Festival Hydro Inc. EB-2023-0021 October 3, 2023

Festival Hydro Inc. OEB Staff Questions EB-2023-0021

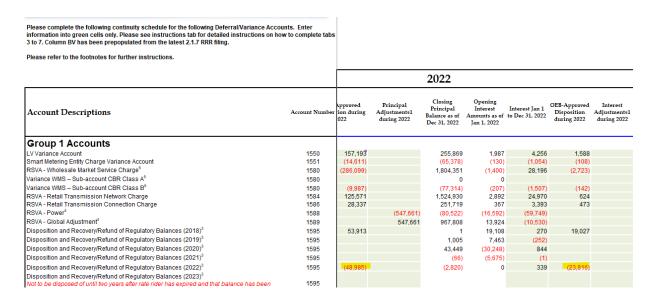
OEB staff has updated LDC's rate generator with the preliminary UTRs/and proposed host RTSR by HONI as follows:

a) Please confirm the accuracy of the Rate Generator update, as well as the accuracy of the resulting Retail Transmission Service Rates following these updates.
